SERVICE BULLETIN
MAINTENANCE OF WAY EQUIPMENT

DATE: 04-2021   **BULLETIN NO:** 18-005C

TITLE: Jupiter I Module Hardware / Software Update

PRODUCT SERIES / MODEL: Harsco Rail Machines Equipped with Jupiter I Control System

FIGURE 1
6700SJI TAMPER LEFT HAND PANEL - JAM LOCATIONS

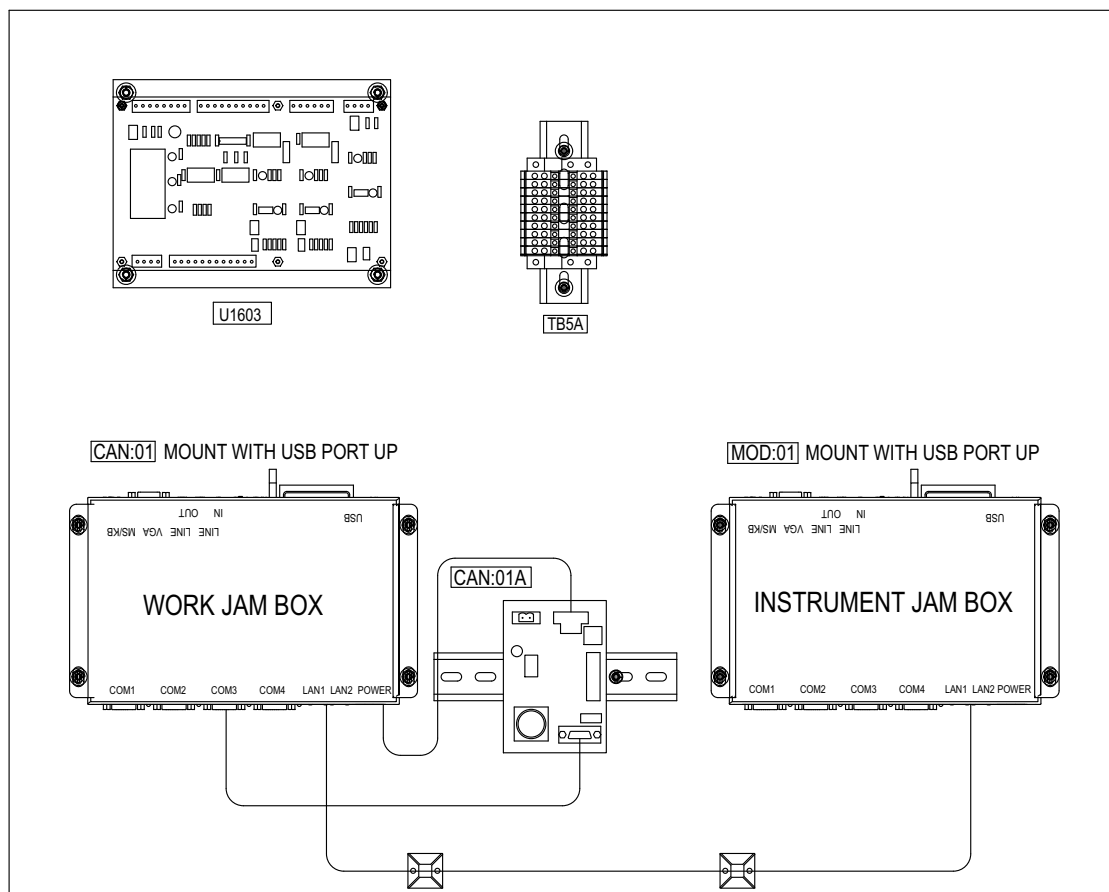
2. See Figure 1.   The 6700SJ1 will require two software upgrade files, one for the WORK JAM and one for the INSTRUMENT JAM. These will be sent to you in two separate e-mails. Figure 1 shows the location of the JAM Boxes on the Left Hand Panel.
